Access Compliance Report

Public Rights-of-Way

(Curb Ramps)

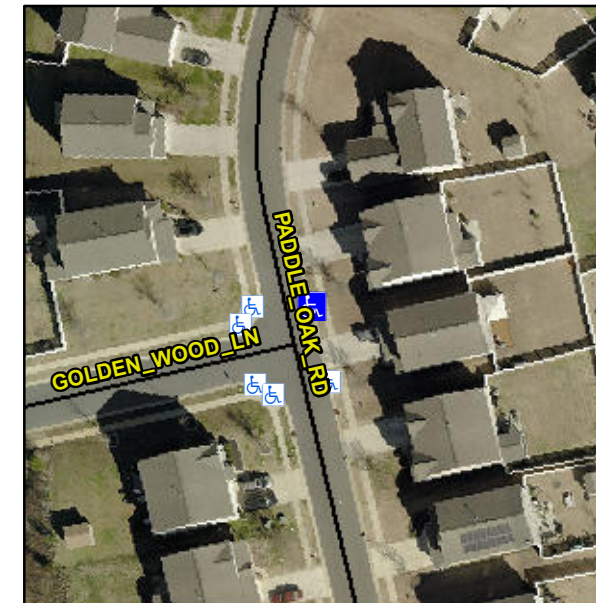
Not Found, R304.5.1, R304.2.2

Compliance	Description	Data	Compliance	Description	Data
N/A	Ramp Length (in)	46.0	No	Ramp Slope (%)	10.9
No	Ramp Width (in)	47.5	Yes	Ramp XSlope (%)	2.8
N/A	Flare Type LT	N/A	N/A	Flare Type RT	N/A
N/A	Flare Slope LT (%)	N/A	N/A	Flare Slope RT (%)	N/A
N/A	Flare Traversable LT?	N/A	N/A	Flare Traversable RT?	N/A
N/A	Landing Length (in)	N/A	N/A	DWS Provided?	N/A
N/A	Landing Width (in)	N/A	N/A	DWS Contrast?	N/A
N/A	Landing Slope (%)	N/A	N/A	DWS Length (in)	N/A
N/A	Landing X Slope (%)	N/A	N/A	DWS Full Width?	N/A
N/A	Landing Curb? (Y/N)	N/A	N/A	DWS Offset (in)	N/A
N/A	Shared Landing?	N/A			
N/A	Gutter Ponding?	N/A	N/A	Gutter Slope (%)	N/A
N/A	Gutter Lip Ht (in)	N/A	N/A	Gutter X Slope (%)	N/A
N/A	Painted X Walk1?	No	N/A	Painted X Walk2?	N/A
	X Walk 1 Direction	To W		X Walk 2 Direction	N/A
N/A	X Walk 1 Width (in)	N/A	N/A	X Walk 2 Width (in)	N/A
	X Walk 1 Slope (%)	0.9		X Walk 2 Slope (%)	N/A
	X Walk 1 X Slope (%)	2.8		X Walk 2 X Slope (%)	N/A

Remove & Replace Entire Ramp.
